**CITY OF MOUNDSVILLE
MARSHALL COUNTY, WEST VIRGINIA
FOUR SEASONS SPLASH PAD**

ADDENDUM #1

April 1, 2021

THRASHER PROJECT #030-10204

SHEET No.
C2.03

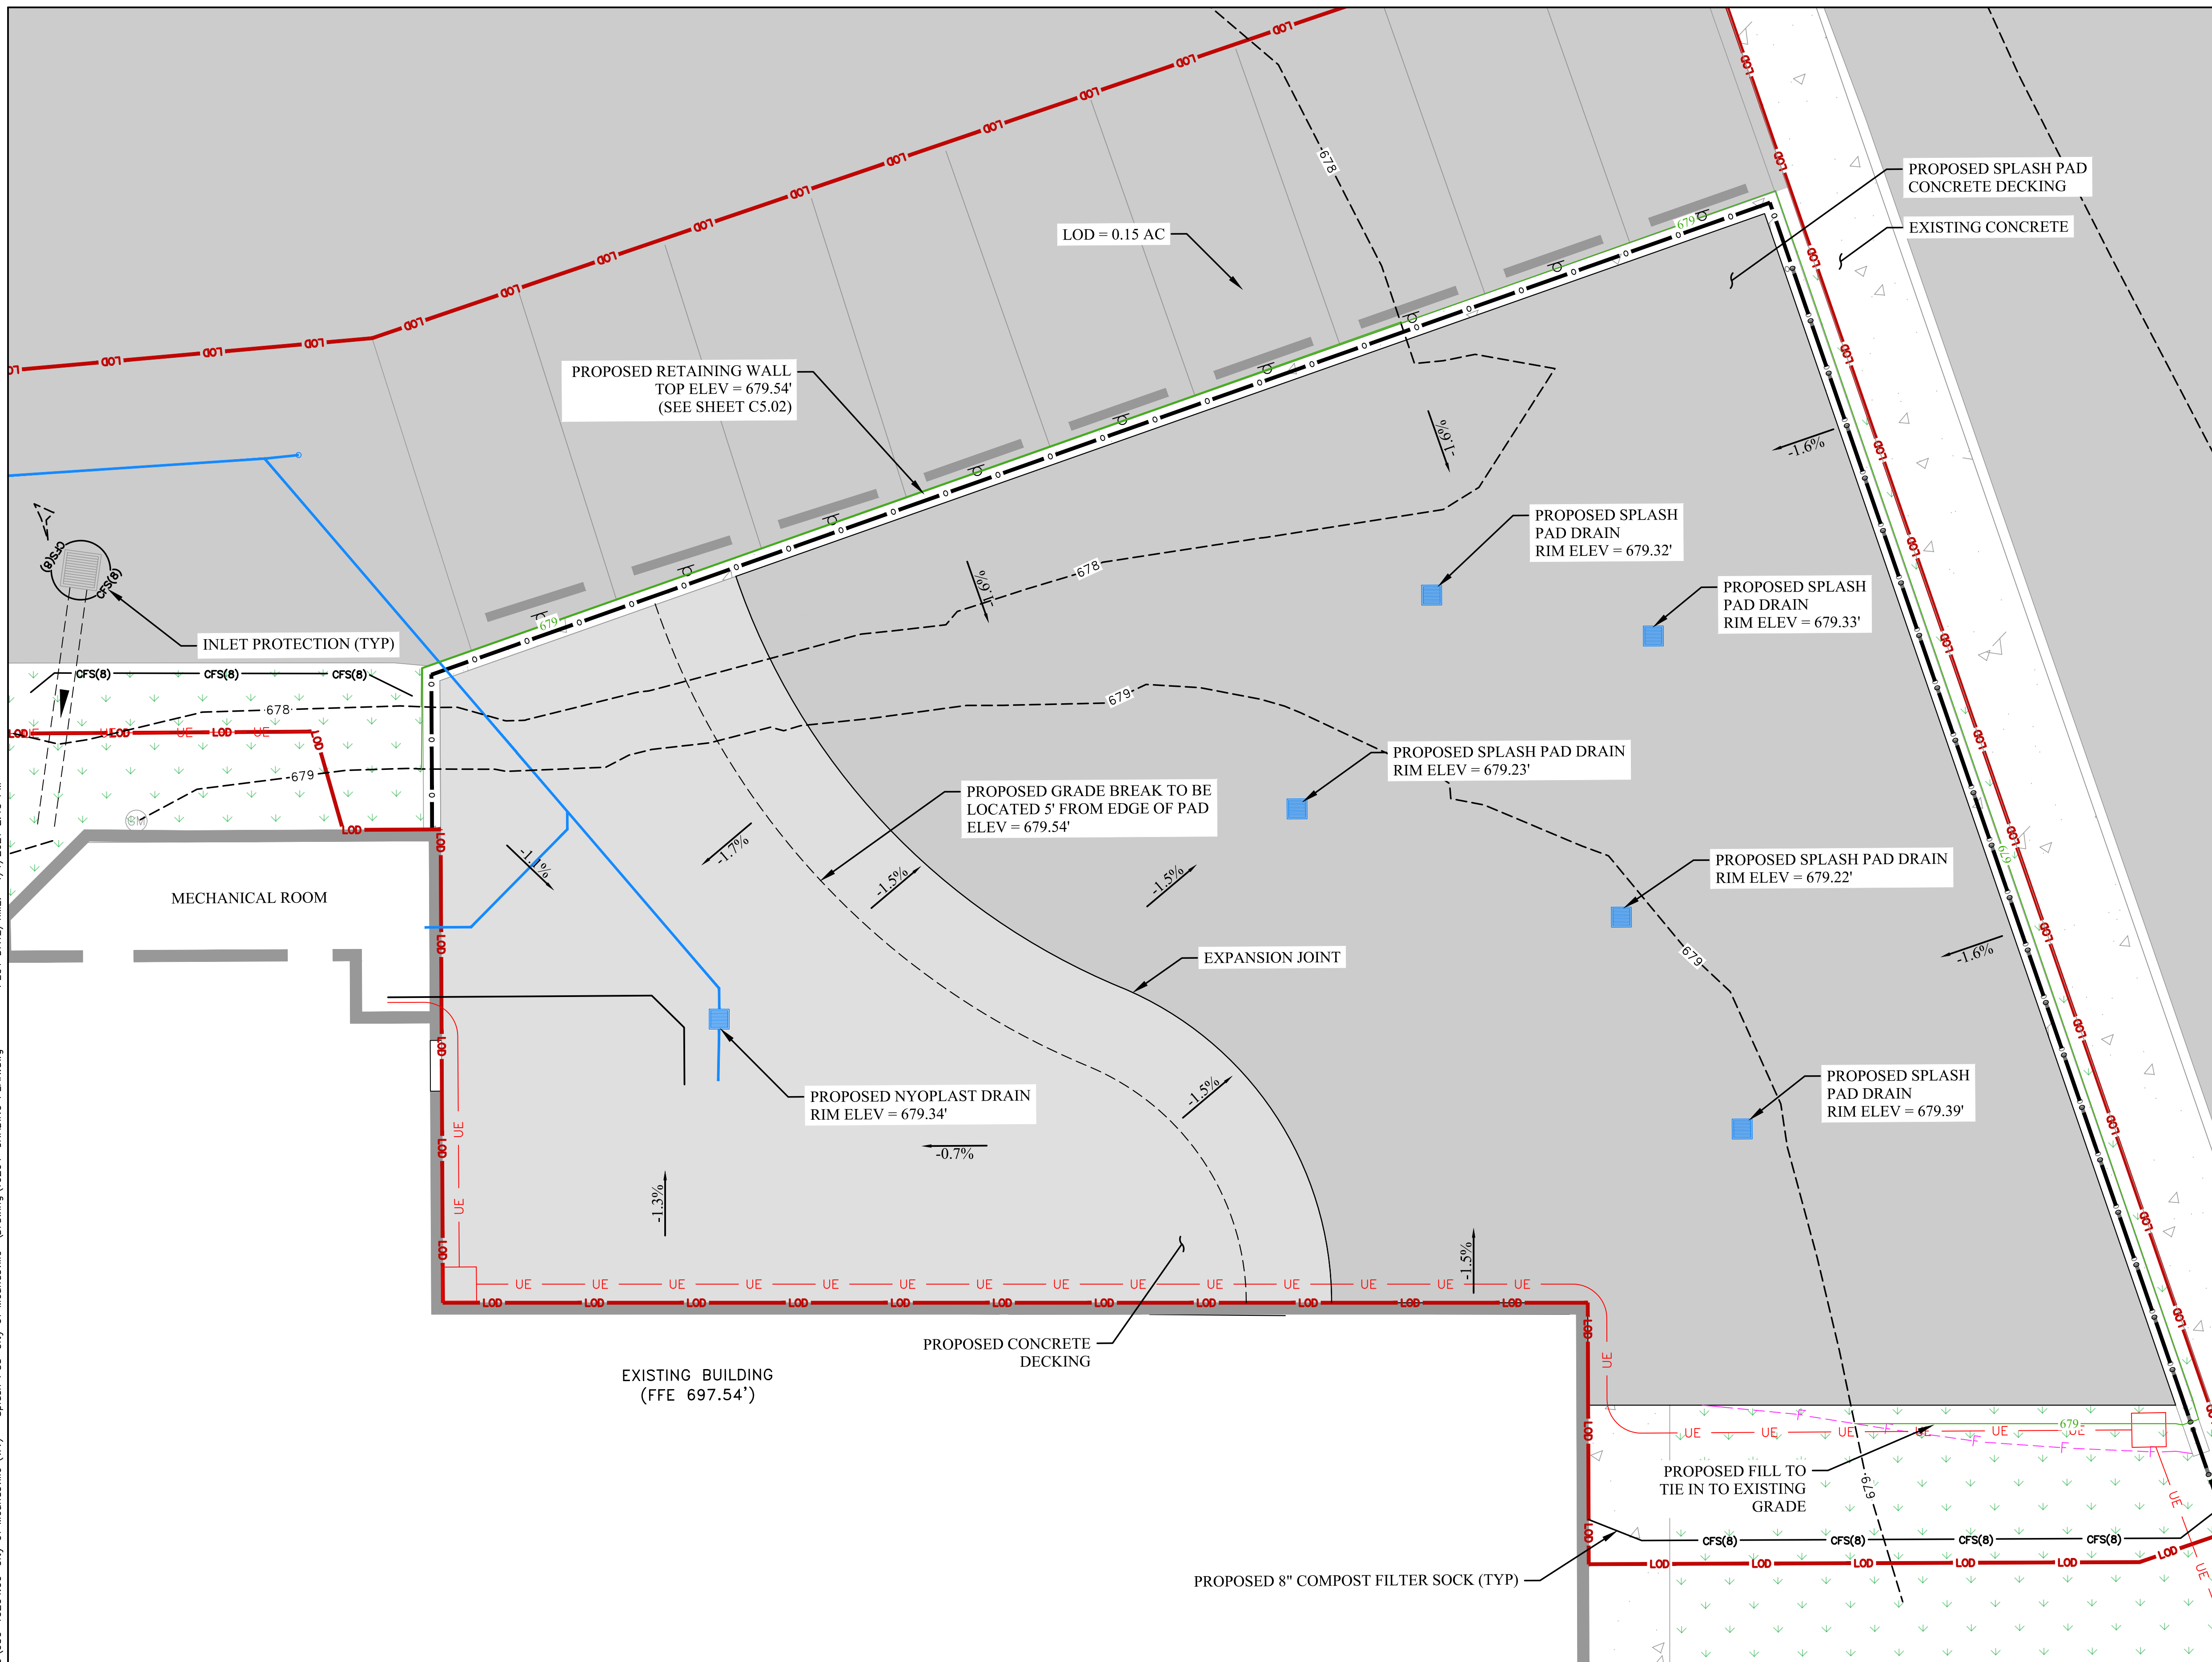
RESPONSE

Refer to revisions on sheet C2.03 for potable water routing. A ¾” copper line connection will be used for the potable water supply. Installation of a backflow preventer and shut-off valve on the supply line will be required. The backflow preventer and shut-off valve shall be installed in the mechanical room.

TYPICAL CONCRETE DECK SECTION
NOT TO SCALE

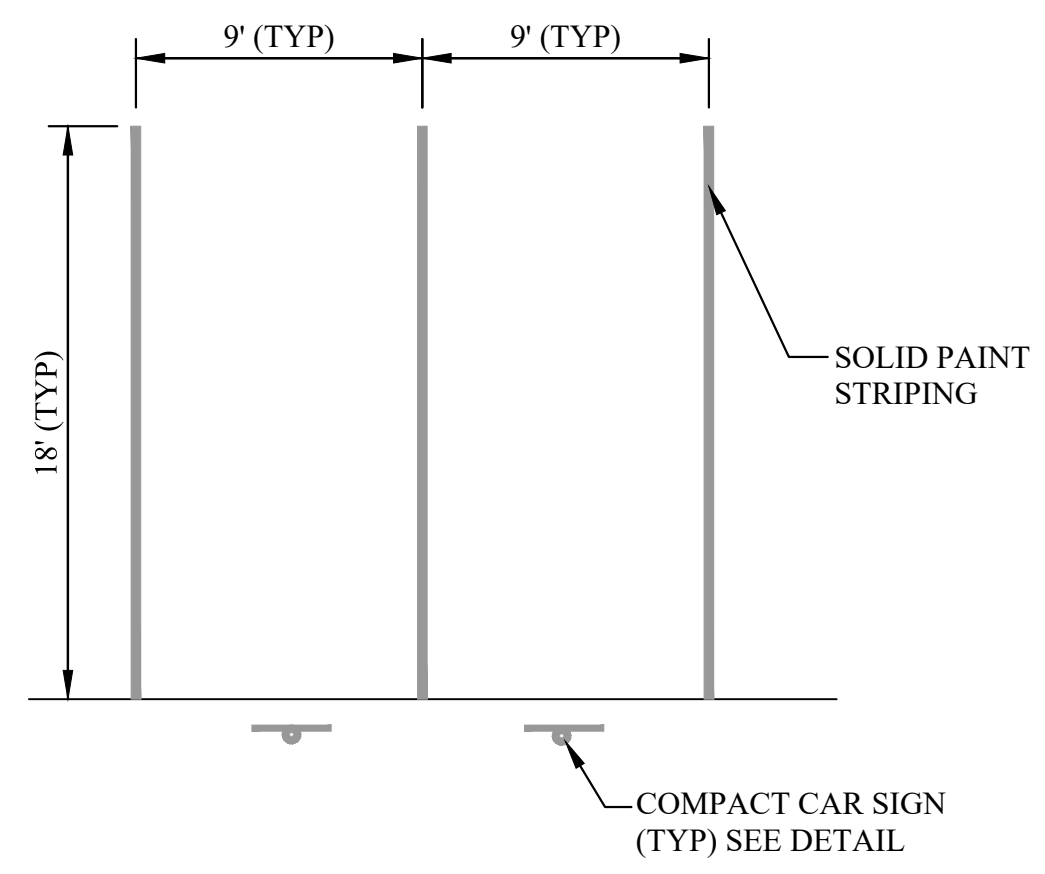
The concrete detail on Sheet C5.03 specifies a non-slip broom swept finish. Can you provide more detail?

The intent of the concrete finish is to provide enough texture to provide traction when wet but not be uncomfortable when walking on it barefoot. A smooth broom finish or light broom finish should be appropriate.

**CHAIN-LINK FENCE DETAIL
NOT TO SCALE**

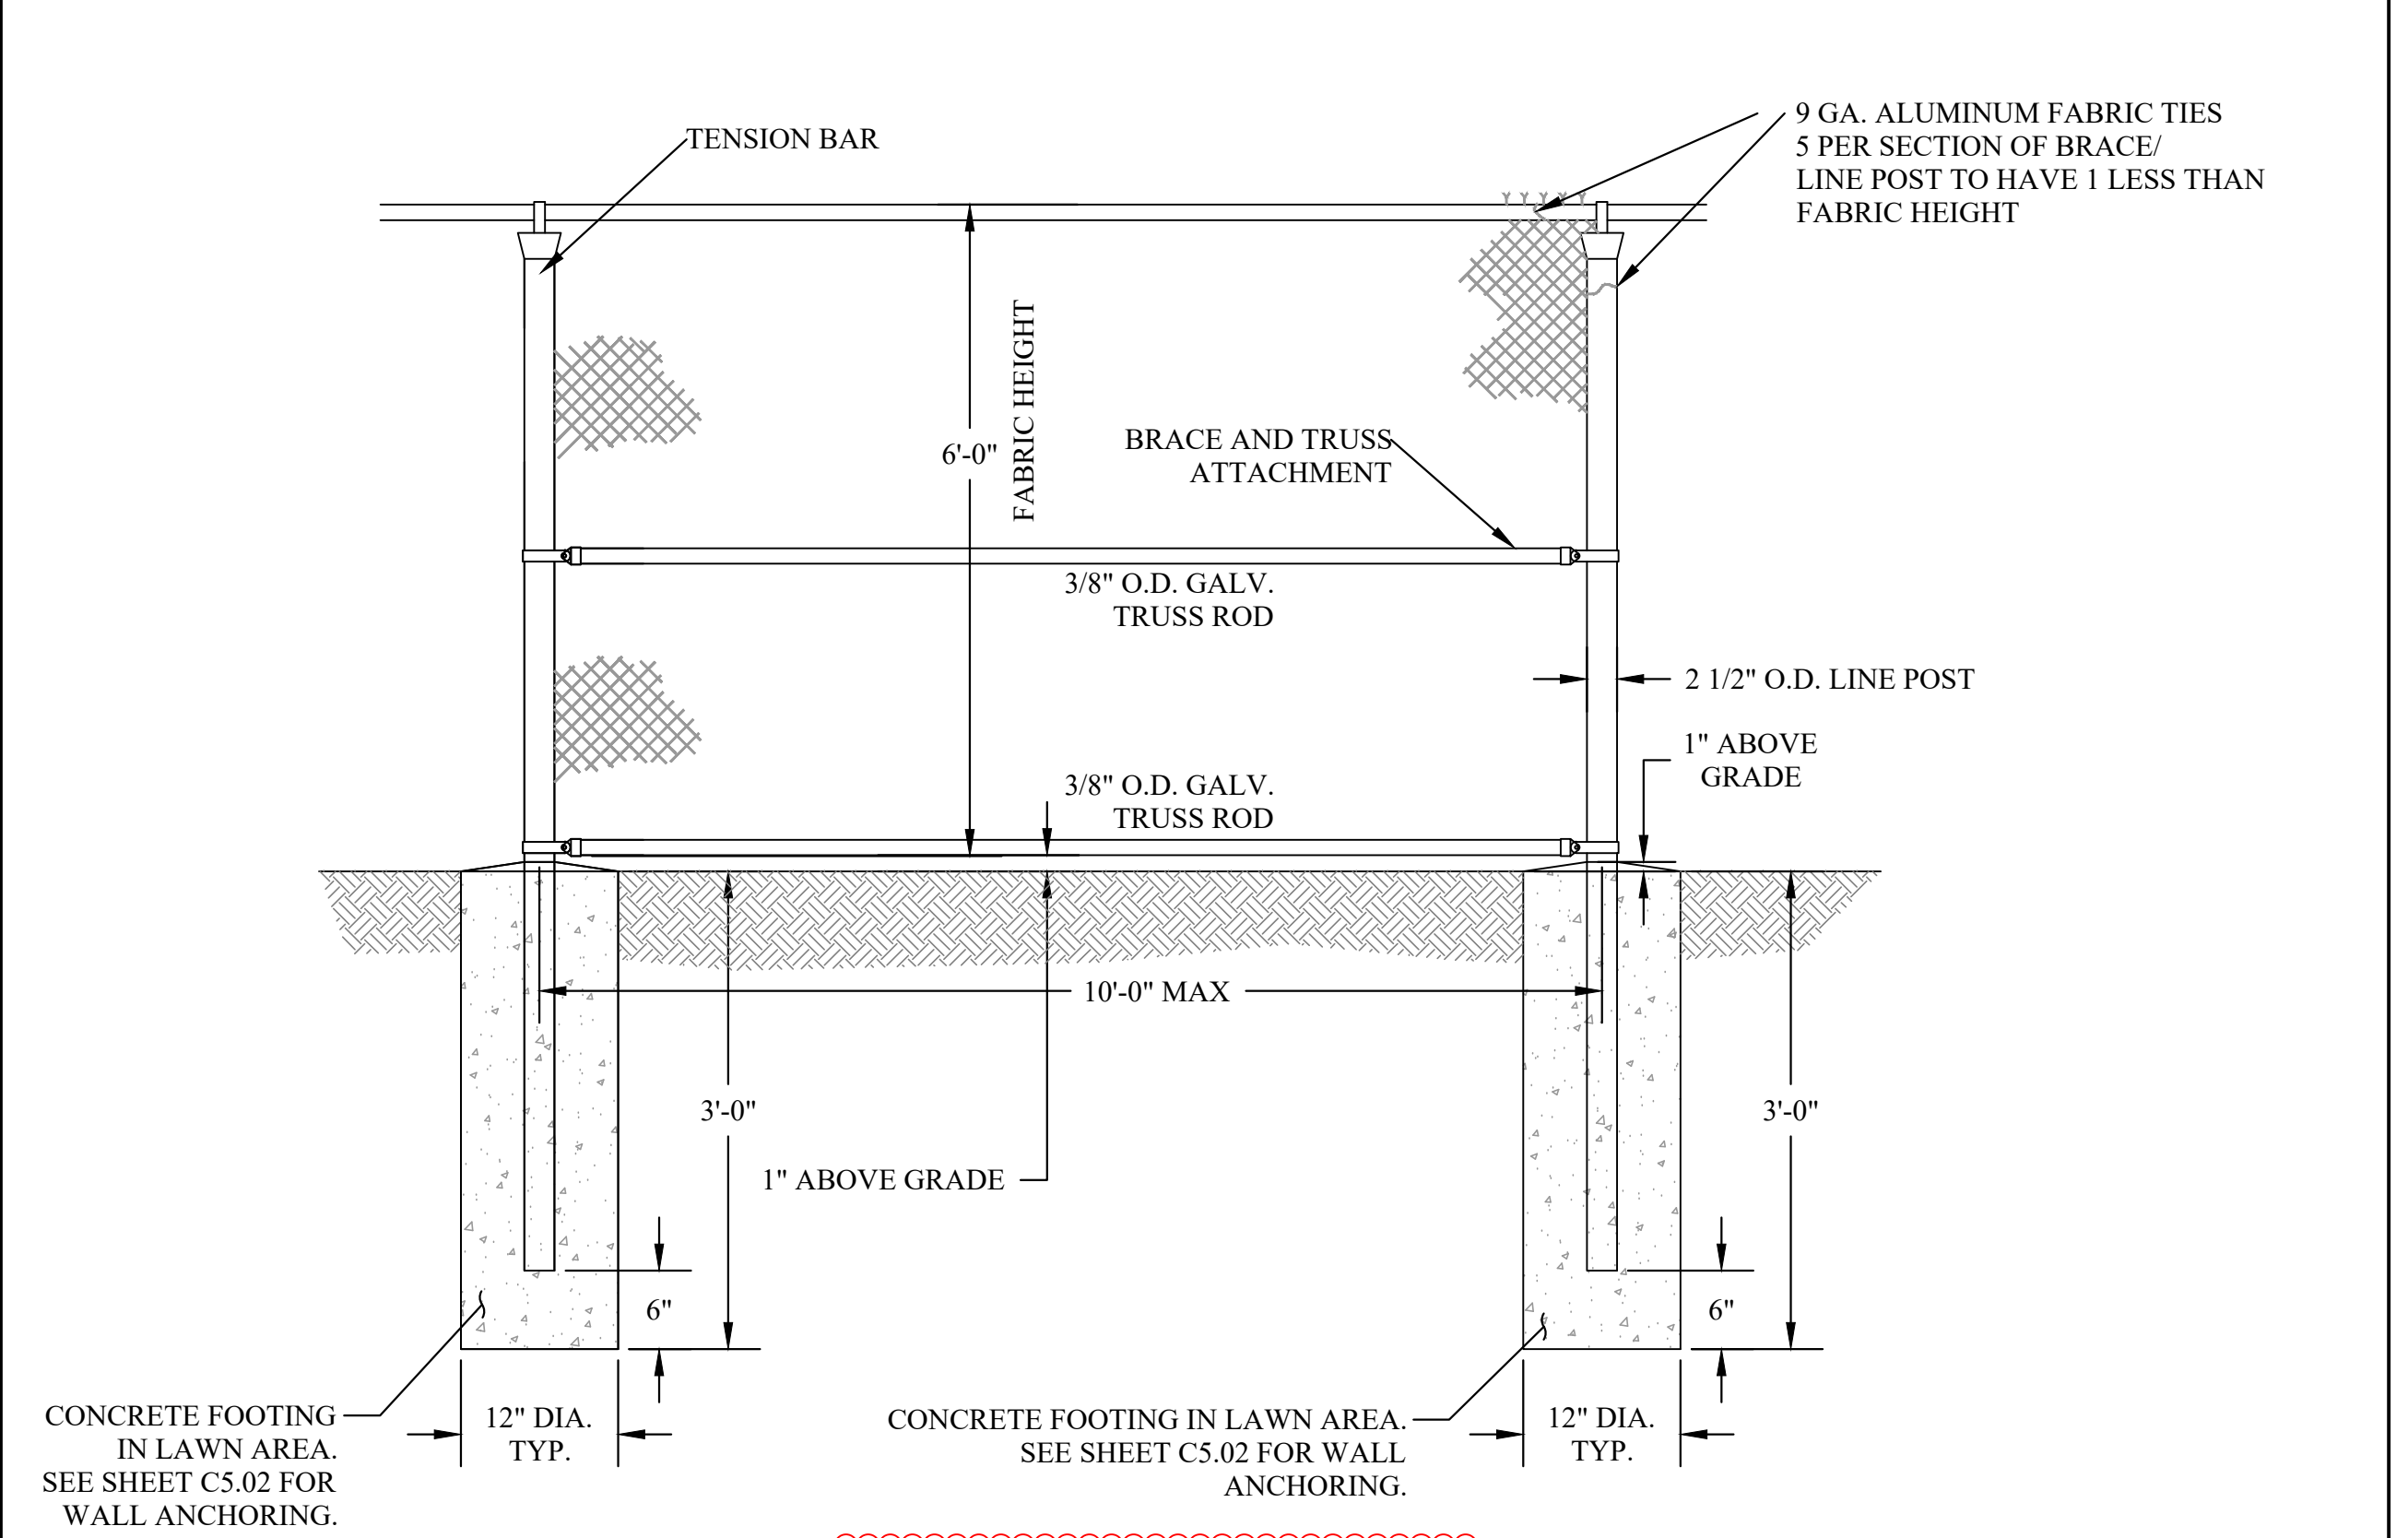
Please confirm the color of the fence. Sheet C5.04 says black chain link detail but in the note section under #8 it says green.

The fence shall be galvanized, with no vinyl coating. The plan drawings and project specifications have been revised accordingly.
